Please see the responses to the comments received below.

LES SCHWAB TIRE CENTER CONSTRUCTION DOCUMENTS

7105 OLD MERIDIAN ROAD FALCON, COLORADO 80831

SITE DEVELOPMENT
PLANS

C000

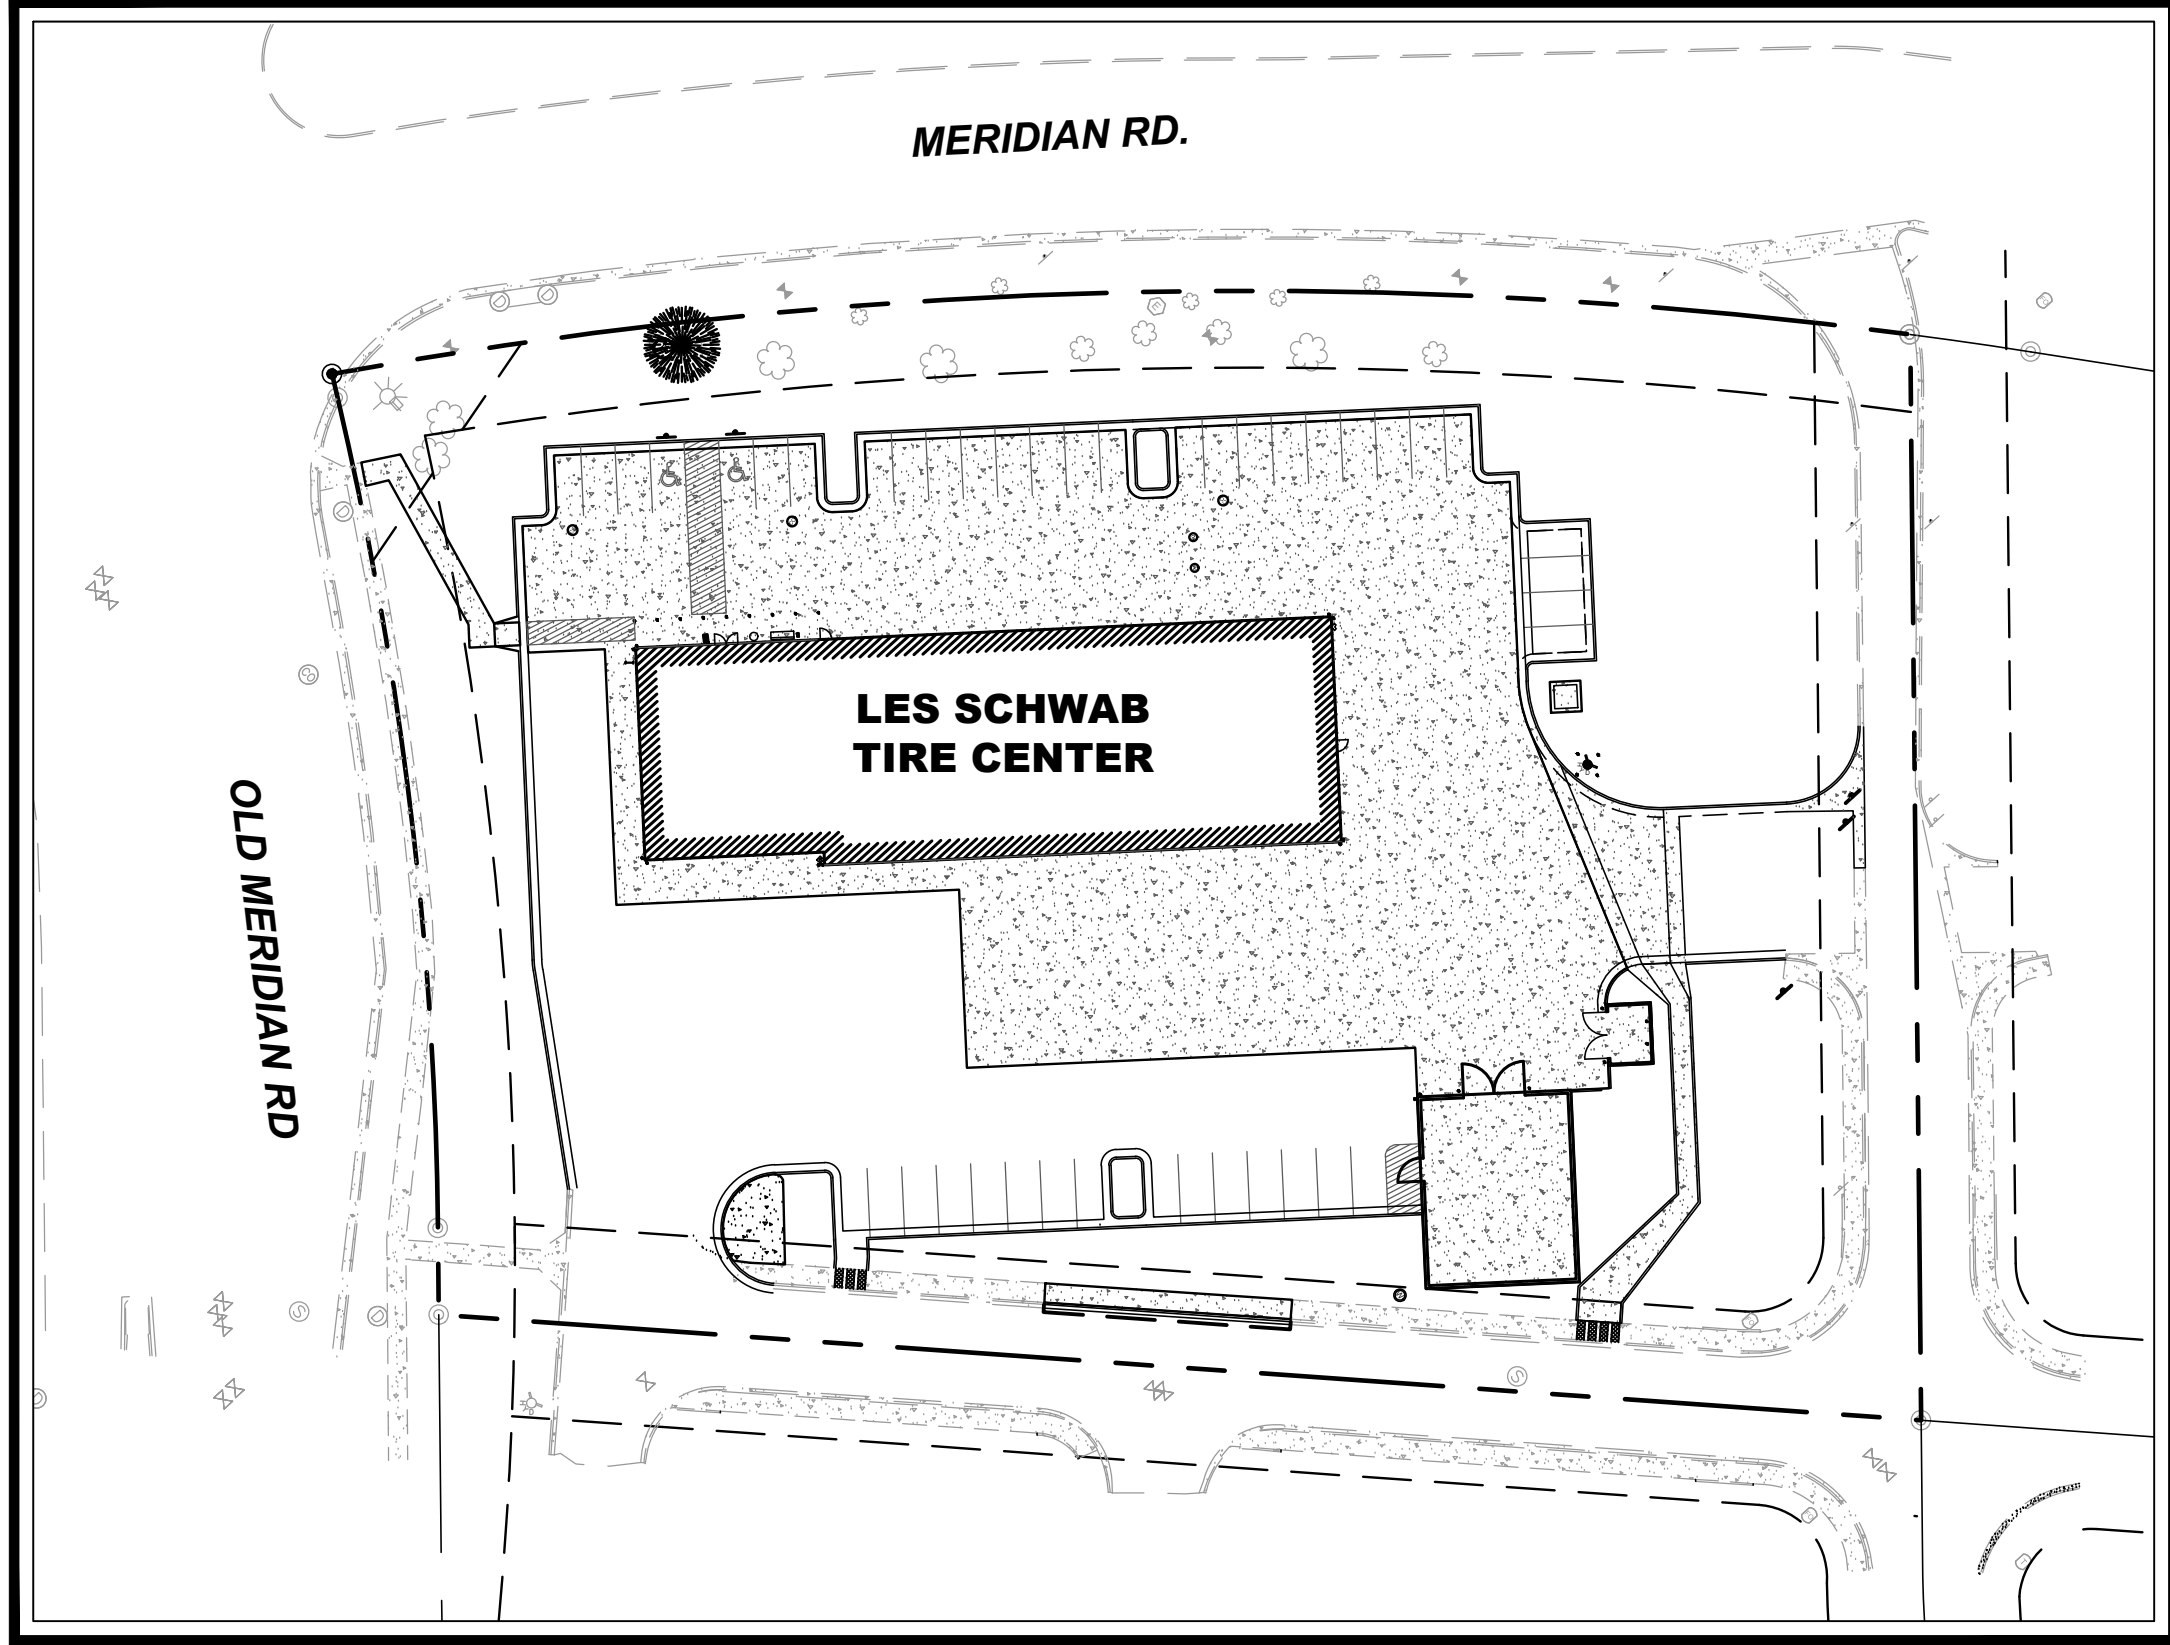
The following note should be added to all site development plans or non-residential site plans, as applicable, prior to PCD approval: The parties responsible for this plan have familiarized themselves with all current accessibility criteria and specifications and the proposed plan reflects all site elements required by the applicable ADA design standards and guidelines as published by the United States Department of Justice. Approval of this plan by El Paso County does not assure compliance with the ADA or any regulations or guidelines enacted or promulgated under or with respect to such laws.

Response: Note has been added to sheet C100

1 EXISTING CONDITIONS PLAN
C001

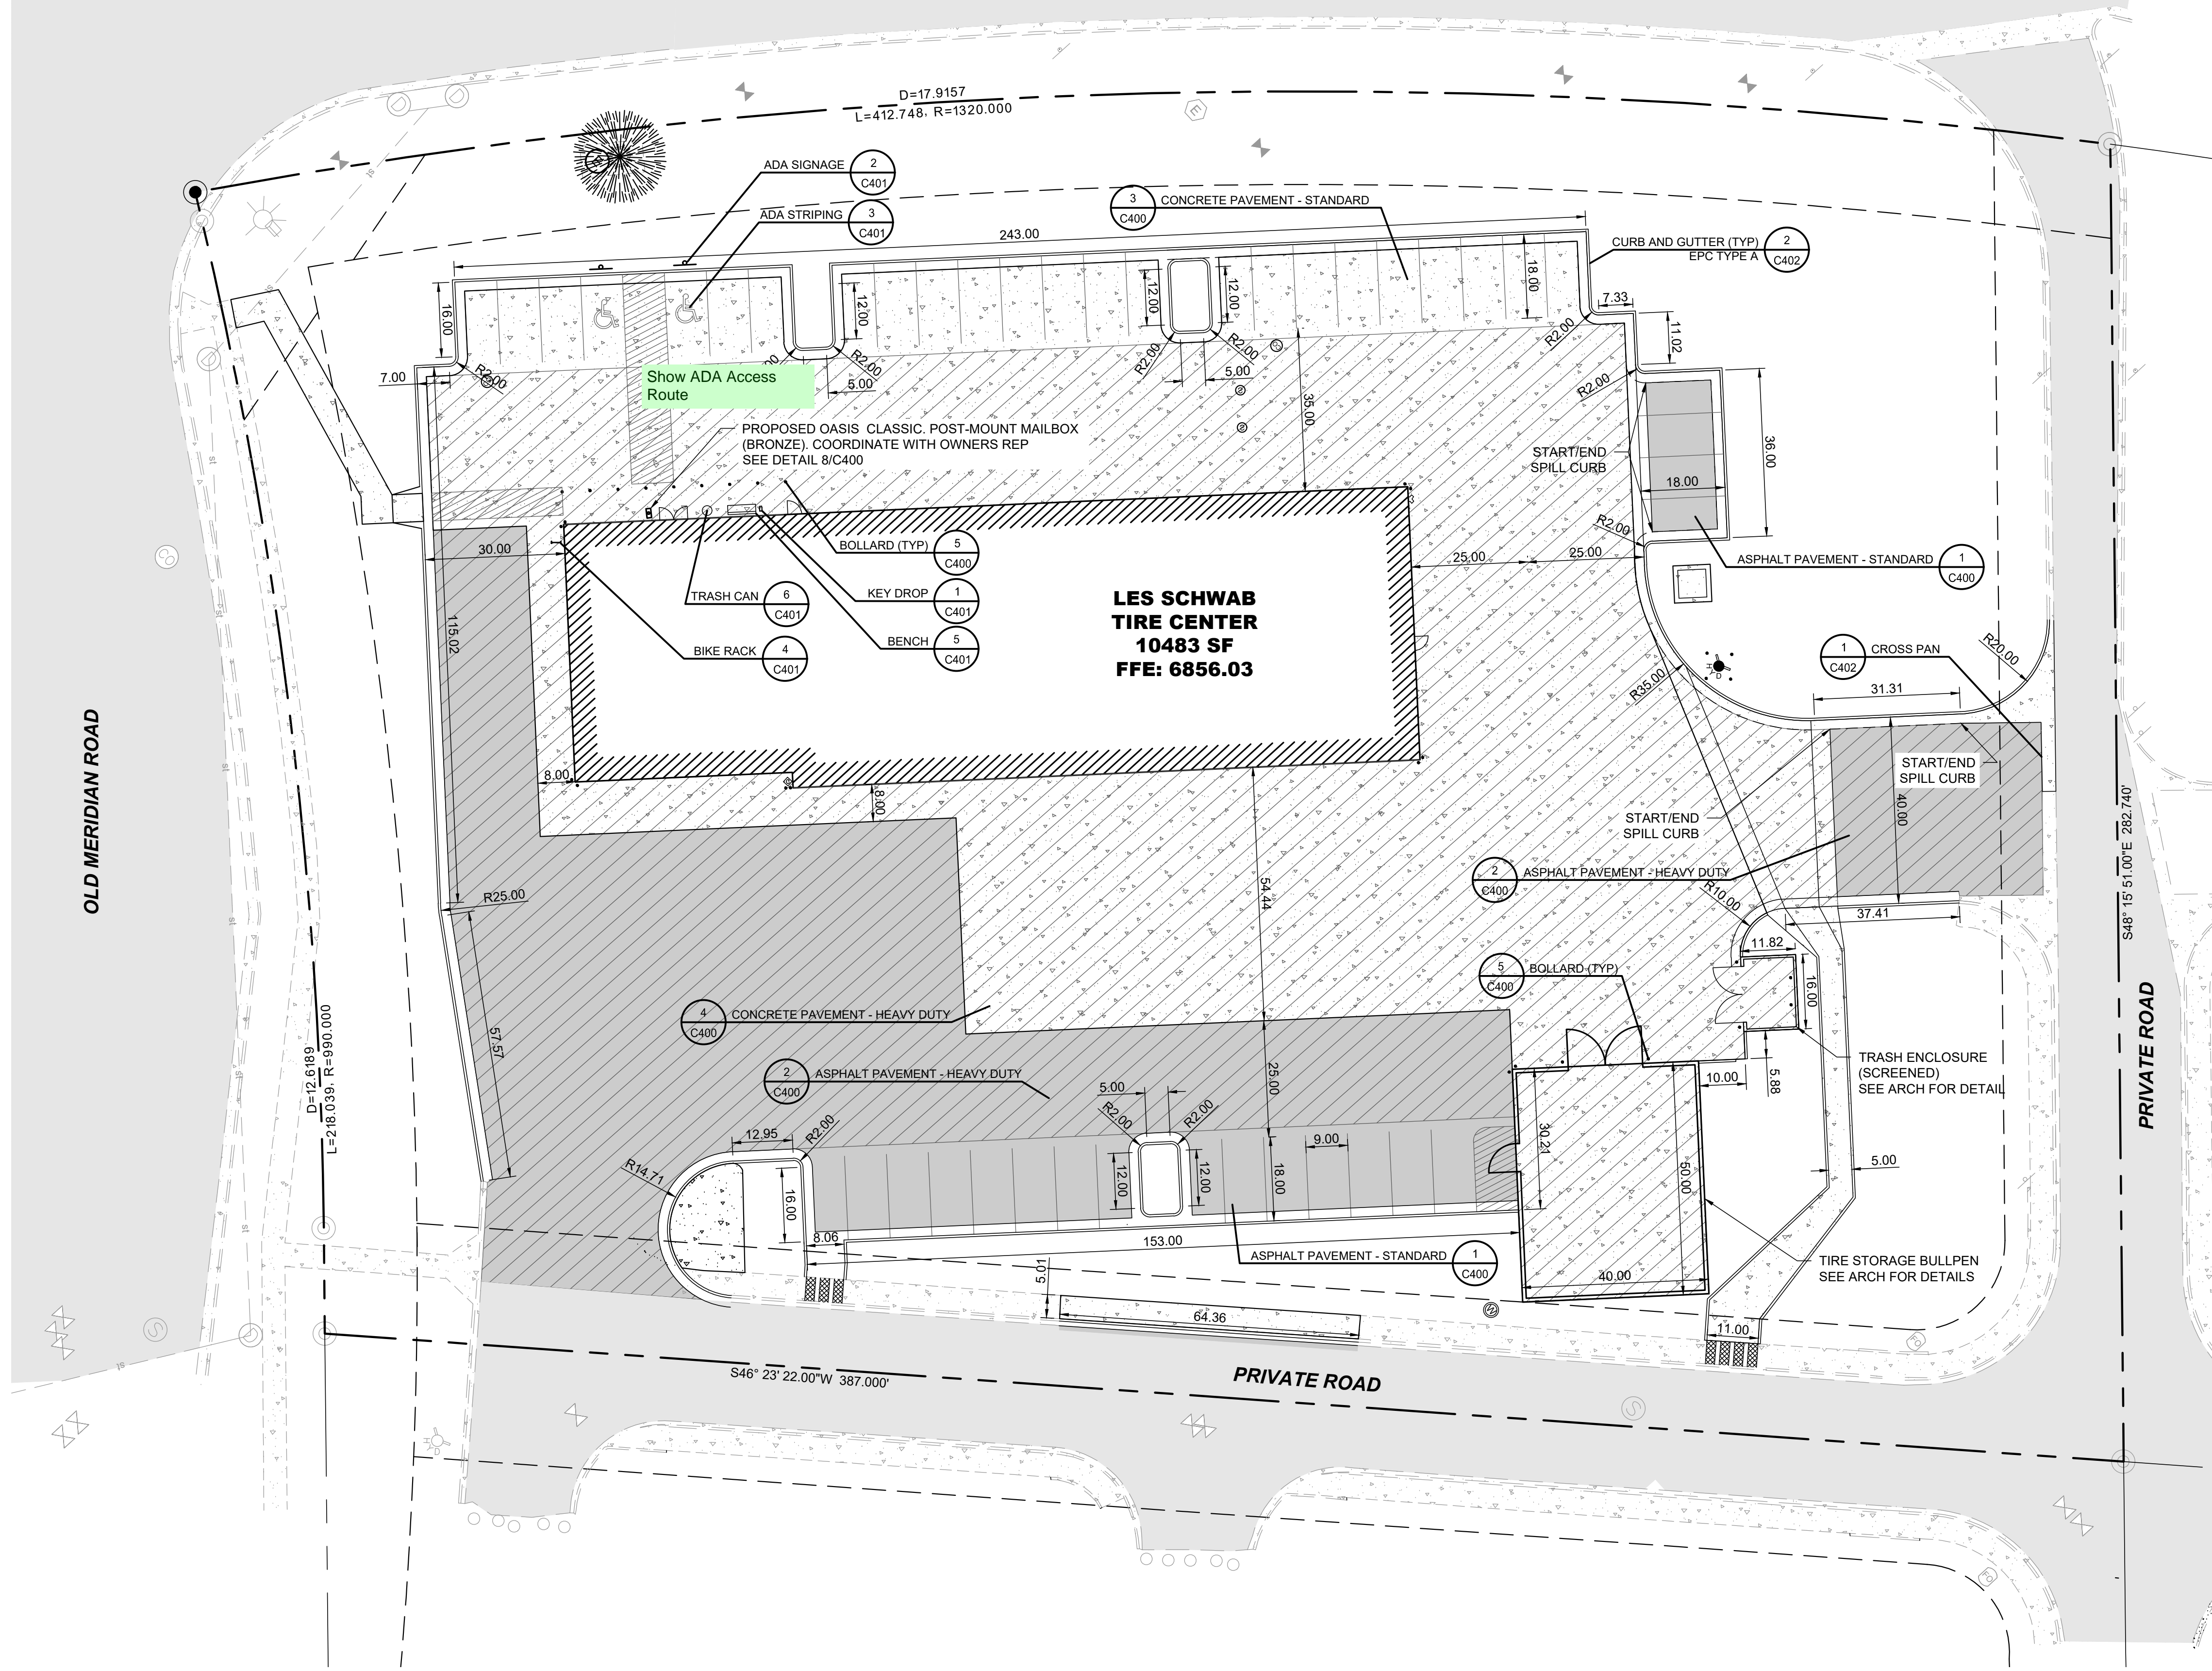
This is not a replat application. Remove "to be vacated" and update site development plan to show all current drainage easements on lot per latest plat.

Response: Note has been edited to state vacation is taking place through separate application.

1 SITE PLAN
C100

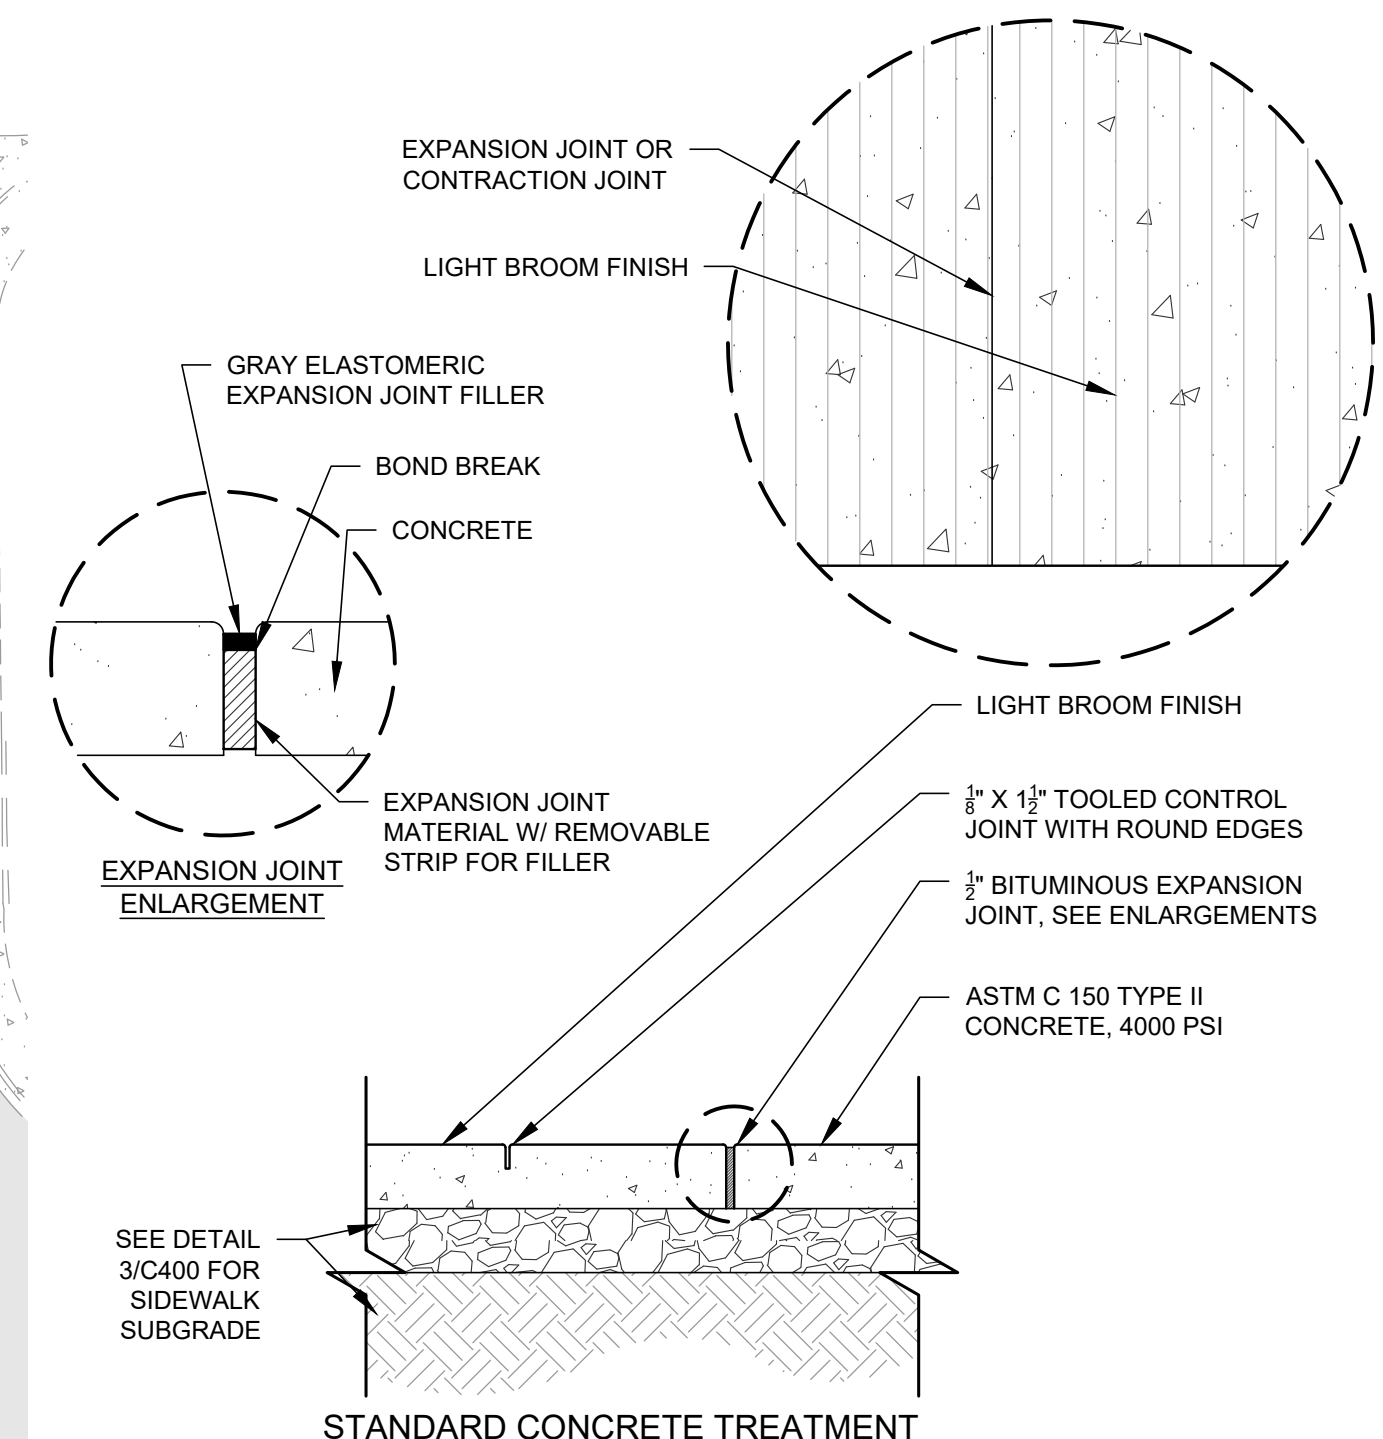
Please provide a site data table. The site data table should include: property address and parcel ID, land use, zoning, lot area, building height, parking (required vs. proposed). Review the dimensional standards included in Chapter 5 and verify all dimensional standards are met.

Response: Site data table has been added to sheet C100.
